Well Name: SAKER 6-7 FEDERAL COM	Well Location: T24S / R35E / SEC 6 / LOT 1 / 32.253325 / -103.400053	County or Parish/State: LEA / NM
Well Number: 4H	Type of Well: OIL WELL	Allottee or Tribe Name:
Lease Number: NMNM014164	Unit or CA Name:	Unit or CA Number:
US Well Number: 3002550472	Operator: OXY USA INCORPORATED

Type of Action: APD Change

Procedure Description: Oxy USA Inc., respectfully requests approval to amend the subject well AAPD to change the SHL, BHL, Pad and amend the casing to our 3-string slim design. See attached APD sundry change overview worksheet along with the updated well plat and drilling documents. The surface hole is moving to an existing pad. "The SHL is moving 140' to the east and there is no additional surface disturbance related to this sundry"

OXY APD CHANGE SUNDRY LIST

Form C-102
Revised August 1, 2011
Submit one copy to appropriate
District Office

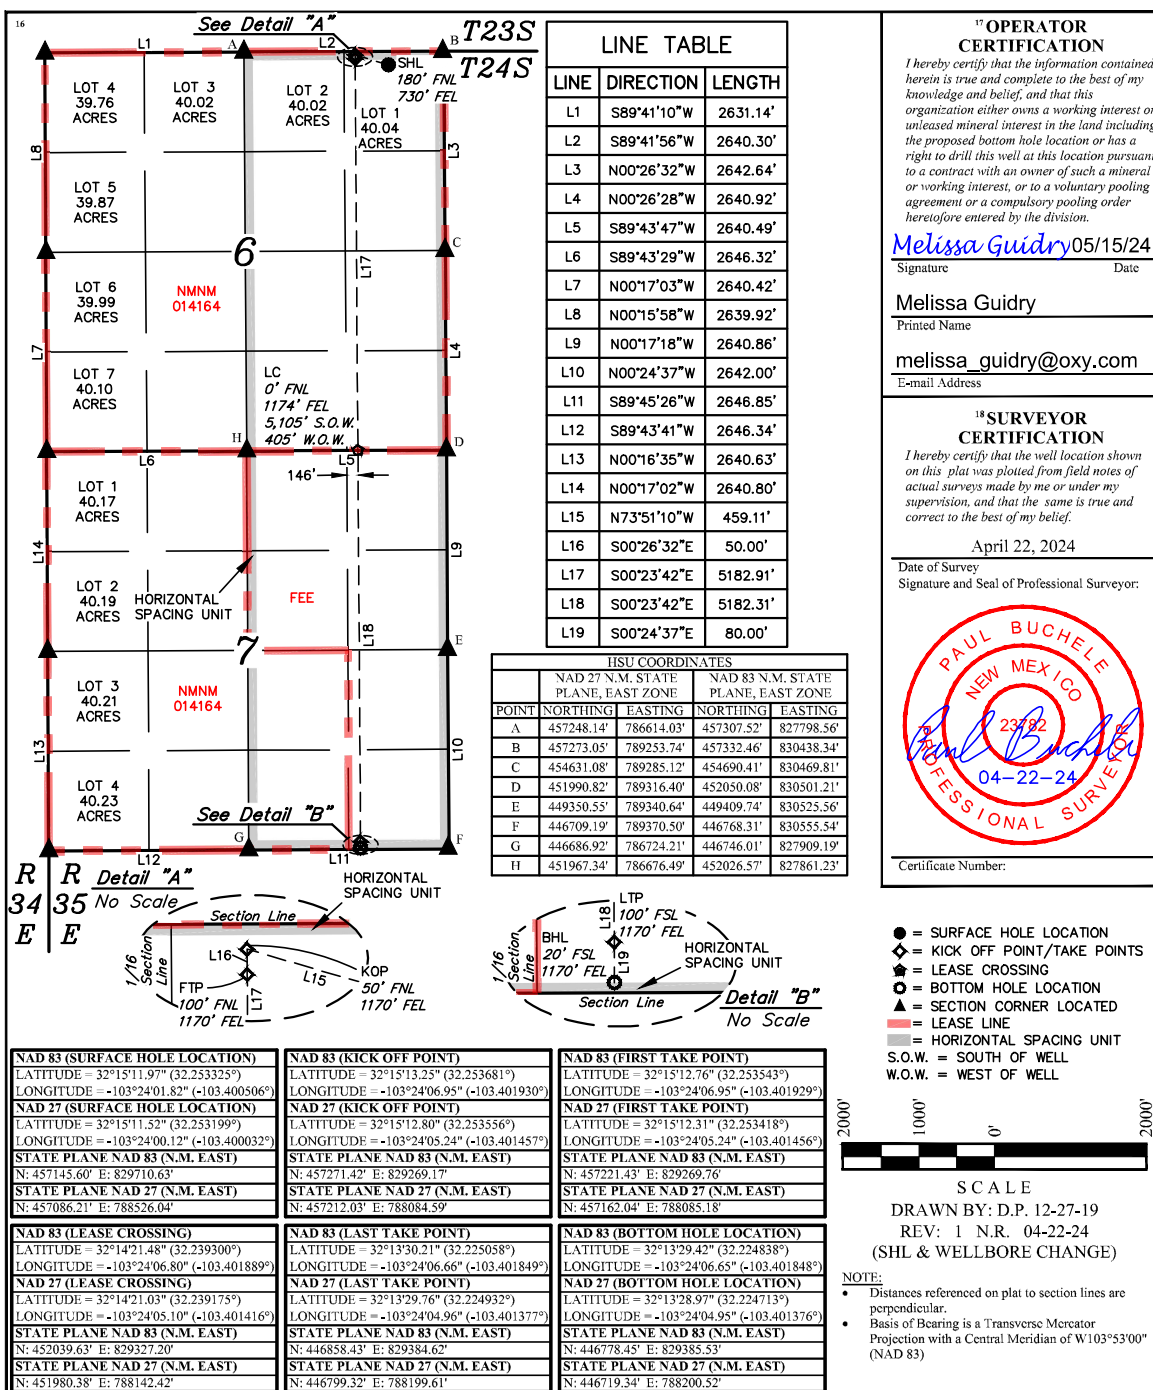
Oxy USA Inc., respectfully requests approval to amend the subject well AAPD to change the SHL, BHL, Pad and amend the casing to our 3-string slim design. See attached APD sundry change overview worksheet along with the updated well plat and drilling documents. The surface hole is moving to an existing pad.

"The SHL is moving 140' to the east and there is no additional surface disturbance related to this sundry"

ITEM	PREVIOUS PLAN	UPDATED PLAN
Surface Planning	NAME	SAKER 6_7 FEDERAL COM 4H	N/A
	NSL	N/A	N/A
	SHL	180 FNL 590 FEL	180 FNL 730 FEL
	PAD	Falcon Ridge 0605 PAD	Falcon_T24SR35E_6_Pad 3
	BHL	20 FSL 2200 FEL	20 FSL 1170 FEL
	HSU SIZE, ACRES	640	N/A
	POOL	Bones Spring	N/A
	TARGET FORMATION	Avalon	THIRD BONE STRING SANDSTONE
Drilling	TVD	19480'	21912'
	SURFACE CASING	17.5 in, 13.375 in, 54.5 lbs, J-55 BTC	14.75 in, 10.75 in, 45.5 lbs, J-55 BTC
	INTERMEDIATE CASING	12.25 in, 9.625 in, 40 lbs, L-80 BTC	9.875 in, 7.625 in, 26.4 lbs, L-80 HC BTC
	INTERMEDIATE 2 CASING	NA	9.875 in, 7.625 in, 29.7 lbs, L-80 HC BTC
	PRODUCTION CASING	8.5 in, 5.5 in, 20 lbs, P-110 DQX	6.75 in, 5.5 in, 20 lbs, P-110 Sprint-SF
	LINER OR TIE BACK	NA	N/A
	CEMENT - SURFACE (TAIL)	893 sxs, 14.8 lb, 1.33 yld, Class C + Accel	697 sxs, 14.8 lb, 1.33 yld, Class C + Accel
	CEMENT - INTERM (TAIL)	155 sxs, 14.8 lb, 1.33 yld, Class C + Accel	420 sxs, 13.2 lb, 1.68 yld, Class C + Ret., Disper
